APPLICATION NO.	FILING DATE	FIRST NAMED INVENTOR	ATTORNEY DOCKET NO.	CONFIRMATION NO.
10/828,843	04/21/2004	James A. Perkins	56527.C1/ C-3670.0	5307

Office Action Summary

DETAILED ACTION

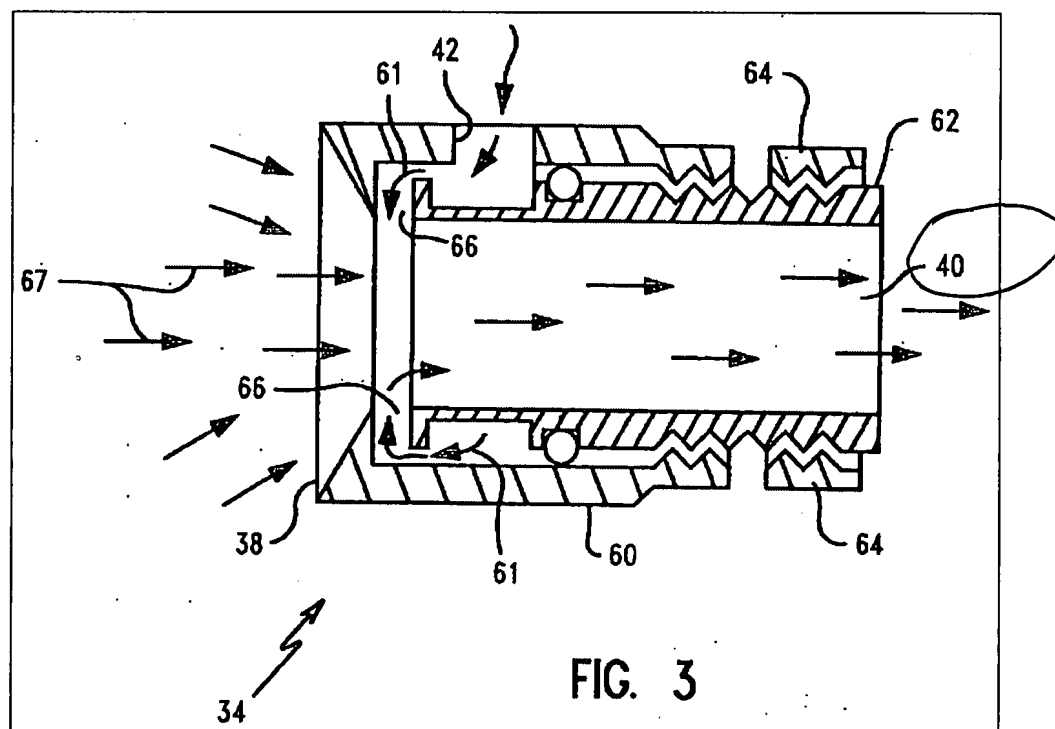
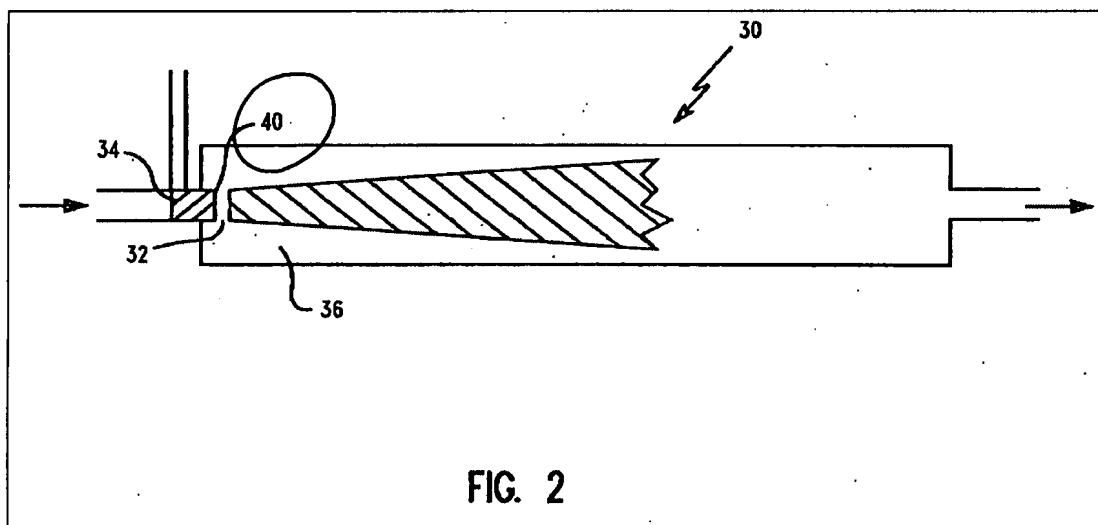
The changes to Fig. 1 are approved. The changes to Fig. 2 are not approved. Deletion of the cross-hatching makes the drawing more difficult to understand. Again, an arrow indicating the compressed air flow in Fig. 2 is missing.

The drawings are objected to because in Fig. 2, it is unclear what the cross-hatched shape in the chamber 36 is intended to represent (it should be labeled), and the flows into the air amplifier 34 need to be labeled with reference numerals. Also, it is unclear what Applicant intends by reference numeral 32 in Fig. 2. Corrected drawing sheets in compliance with 37 CFR 1.121(d) are required in reply to the Office action to avoid abandonment of the application. Any amended replacement drawing sheet should include all of the figures appearing on the immediate prior version of the sheet, even if only one figure is being amended. The figure or figure number of an amended drawing should not be labeled as "amended." If a drawing figure is to be canceled, the appropriate figure must be removed from the replacement sheet, and where necessary, the remaining figures must be renumbered and appropriate changes made to the brief description of the several views of the drawings for consistency.
